Scientific Analysis/Calculation Error Resolution Document

1. Originator: Paul Reimus	2. Date: 4/22/08	3. ERD No. ANL-NBS-HS-000031 ERD 01 <i>Draft D</i> <i>5/27/08</i>
4. Document Identifier: ANL-NBS-HS-000031 REV02 ACN01	5. Document Title: Saturated Zone Colloid Transport

Attachment B

Changes to Relevant Pages from ANL-NBS-HS-000031 REV 02 ACN 01

Figure 6-4. Colloid Filtration Rate Constants, k_f , as a Function of Mean Residence Time in Several Laboratory Experiments and a Field Study in Saturated, Alluvium Material

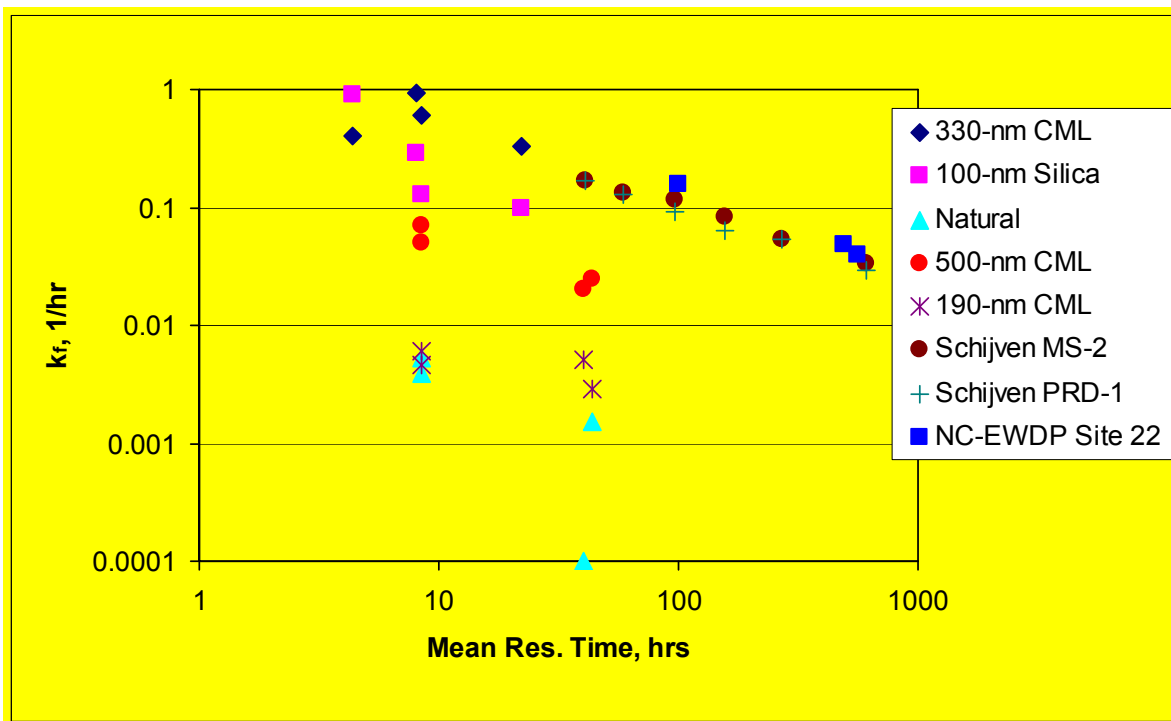
CR 10532: The data points associated with "Schijven MS-2" and "Schijven PRD-1" in Figure 6-4 of ANL-NBS-HS-000031 REV 02 are not correct. This error occurred because the wrong column of information from the source data spreadsheet was plotted. The correct data was used in all the analyses contained in the spreadsheet, so the error applies only to the plot itself, and it does not affect any of the conclusions of the analysis report.

CR 10532 identified what was strictly a plotting error in Figure 6-4 of ANL-NBS-HS-000031 REV 02 ACN 01. There are no impacts to the analyses in ANL-NBS-HS-000031 REV 02 ACN 01 or to any downstream technical products because this error was not propagated to the analyses. The correct data were used in all the analyses in ANL-NBS-HS-000031 REV 02 ACN 01.

The plotting error identified in CR 10352 is corrected as shown in Figure 6-4 of Attachment A. Because correct data were used in all the analyses in ANL-NBS-HS-000031 REV 02 ACN 01, the correction to the figure has no impacts to the analyses in ANL-NBS-HS-000031 REV 02 ACN 01 or to any downstream technical products.

Figure 6-7. Unretarded Fraction Cumulative Probability Distribution for the Fractured Volcanics, Alluvium, and the Combined Distribution of the Volcanics and Alluvium (diamonds correspond to an exponential fit to the combined curve)

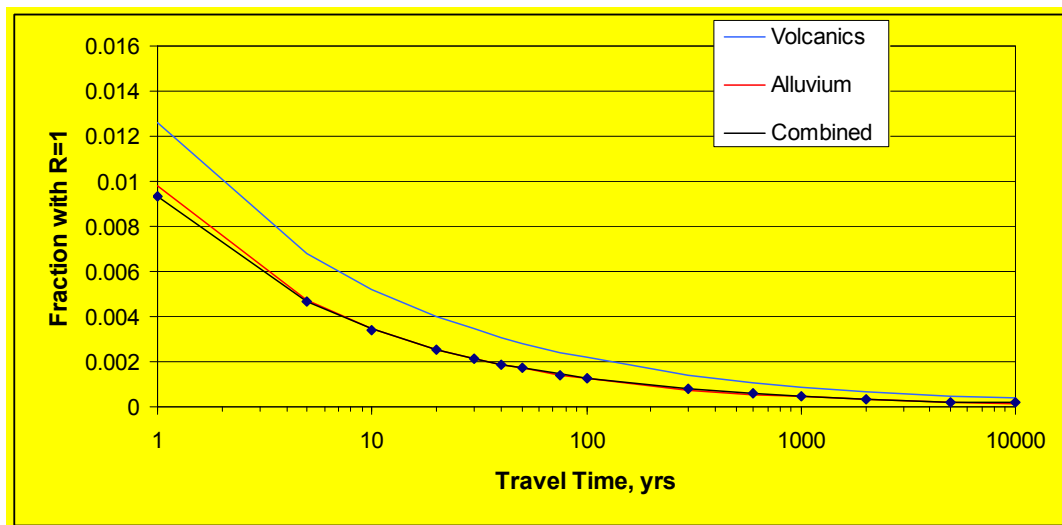
The supersession of DTN: LA0301AA831352.001 with DTN: LA0711PR150304.004 and the revision of DTN: LA0303PR831361.001 also affect the fraction of colloids transporting with no retardation, which is discussed in Section 6.6 of ANL-NBS-HS-000031 REV 02 ACN 01. A revised analysis discussion is provided in Section 6.6 of Attachment B (data contained in Attachment A). The revised analysis shows that the fraction of colloids transporting with no retardation is 0.00170 for an associated combined transport time in the fractured volcanics and alluvium of 50 years. In the original document, and in MDL-WIS-PA-000005 REV 00, ADD 01, *Total System Performance Assessment Model/Analysis for the License Application*, the fraction of colloids with no retardation is 0.00168 and the associated combined transport time is 100 years. Thus, both the colloid fast fraction and the associated travel time are different in the revised analysis as compared to the TSPA. However, the difference in the fast fraction is only 1.2%, which is negligible given all the uncertainties associated with the estimation of the fast fraction (see parent analysis report). Furthermore, this difference would disappear if the two values were rounded to two significant figures, which is considered entirely appropriate. The

associated transport time was decreased from 100 years to 50 years so that the fast fraction would remain approximately the same as in the original analysis report and in the TSPA. The original transport time of 100 years was conservatively chosen to be somewhat less than the median transport time in the saturated zone, so the selection of an equally arbitrary 50-year transport time does not constitute any loss of defensibility, and in fact, it adds to the conservatism in the fast fraction estimate because the fraction increases as transport times decrease. The revised analysis would yield a fast fraction of 0.00126 if the transport time were kept at 100 years, and the corresponding impact on TSPA would be a reduction in dose associated with the transport of unretarded colloids that have irreversibly-sorbed radionuclides. Thus, given all the uncertainties in the estimate of the colloid fast fraction and the fact that the revised analysis yields a smaller fast fraction for the transport time assumed in the TSPA, it is concluded that there is negligible impact of the revised analysis on the TSPA.

Figure 6-17. ³HHO and Colloid Breakthrough Curves and RELAP Fits in Test 1, Column C (6.01 mL/hr Flow Rate)

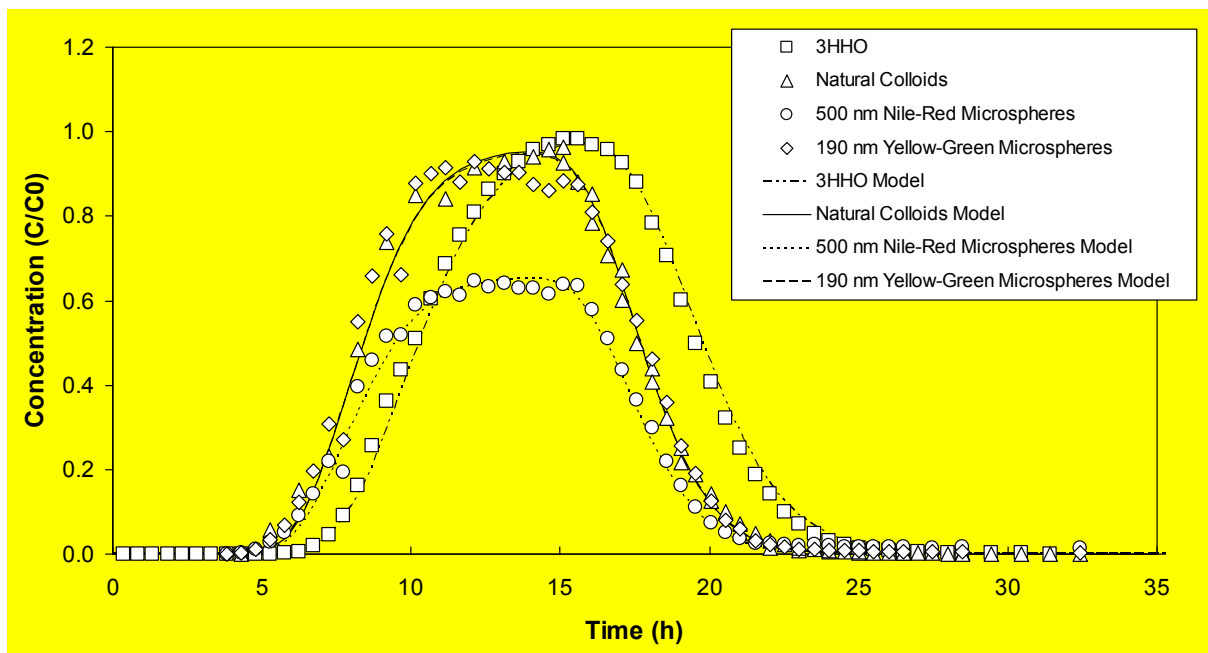
CR 11155: Errors affecting ANL-NBS-HS-000031 REV 02 were found in DTN LA0301AA831352.001. The tritium concentrations for "Run 1 Column A" were associated with the wrong cumulative sample collection weights, causing the tritium breakthrough curve to be shifted to earlier times and smaller volumes than it should have been. When this error is corrected, the tritium breakthrough curve relative to the colloid breakthrough curves in this run/column is much more consistent with the behavior observed in the other runs and columns reported in DTN LA0301AA831352.001. The error associated with the tritium breakthrough curve in Run 1 Column A is reflected in Figure 6-17 the analysis report, so this figure is revised. Also, the tritium model curve in Figure 6-17 and the transport parameters (RELAP model parameters) for tritium and the colloids in the column labeled "6.01, Col. C" of Table 6-16 are revised. These new transport parameters are reflected in a revision to DTN LA0303PR831361.001, which contains the RELAP model analyses of the data in LA0301AA831352.001.

The experiments were interpreted in the same way as the first set of colloid transport experiments in alluvium-packed columns (i.e., first, the mean residence time and Peclet number of ³HHO in each experiment was determined using the RELAP computer code (STN: 10551-2.0-00), and then colloid filtration rate constants and retardation factors were determined for the colloids assuming that the ³HHO Peclet numbers applied to the colloids). The mean residence times of the colloids were allowed to be adjusted because the colloids broke through the columns significantly earlier than the ³HHO in three of the four experiments. The breakthrough curves of the ³HHO and colloids in each experiment are shown in Figures 6-17 through 6-20. Also shown in these figures are the RELAP fits to each data set. The ³HHO and colloid transport parameters obtained from the fits are listed in Table 6-16.
